# UNITED STATES PATENT AND TRADEMARK OFFICE

10/049,272

<b>Office Action Summary</b>	<b>Application No.</b> 10/049,272	<b>Applicant(s)</b> ENGEL ET AL.	
	<b>Examiner</b> KEVIN M. NGUYEN	<b>Art Unit</b> 2629

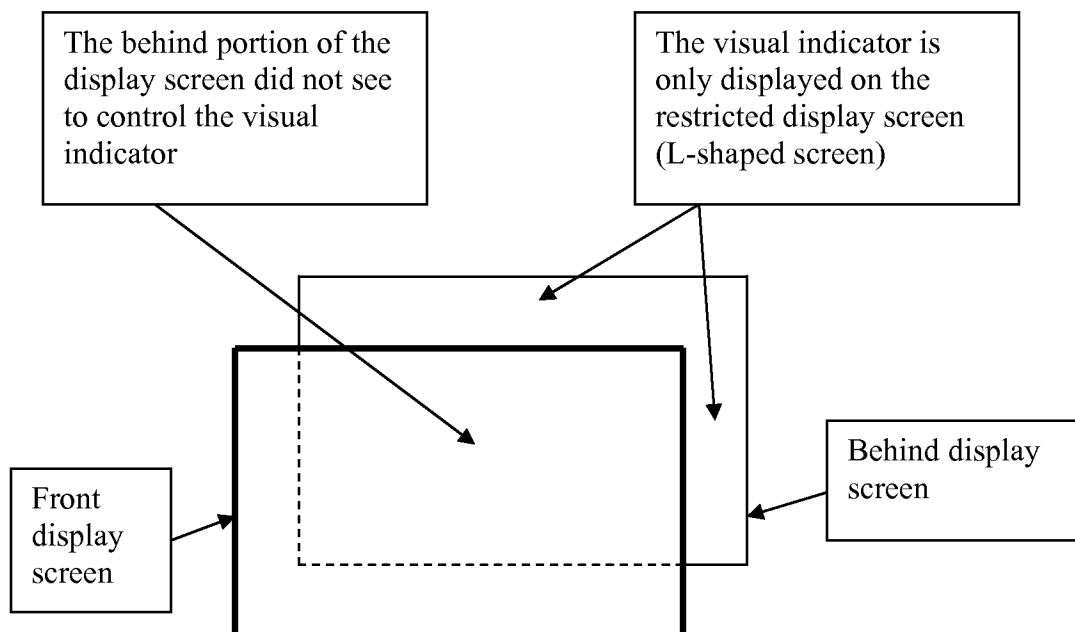
Claims 134-172 are rejected under 35 U.S.C. 101 because the claimed invention is not supported by either “said user-selectable input component is configured to move said visual indicator from a first display screen to a second display screen, [said first and second screens

overlap], in response to a first user interaction with said user-selectable input component” asserted utility or a well established utility.

The figure below, which is drawing by the claim 134, in which the claimed invention lacks patentable utility, where the only restricted display screen configured to move the visual indicator.
